Stage 1 Road Safety Audit

Market Street to Barrack Lane Pedestrian
Improvements Scheme, Granard, Co. Longford

On behalf of Longford County Council

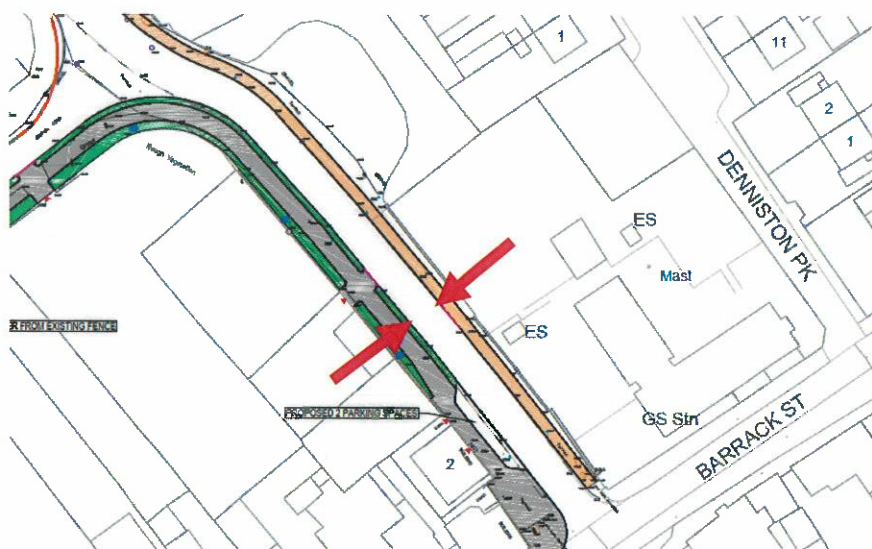
Problem: There is no existing street lighting on the link road. Street lighting is indicated on the proposals drawings, but this appears to be spaced wide apart and not located at the tight bends along the route. There is concern that insufficient lighting level or spread will be provided along the route.

Hazard: Trip/fall injuries may result.

Recommendation: The team should undertake an assessment of the lighting levels and provide additional street lights if deemed required.
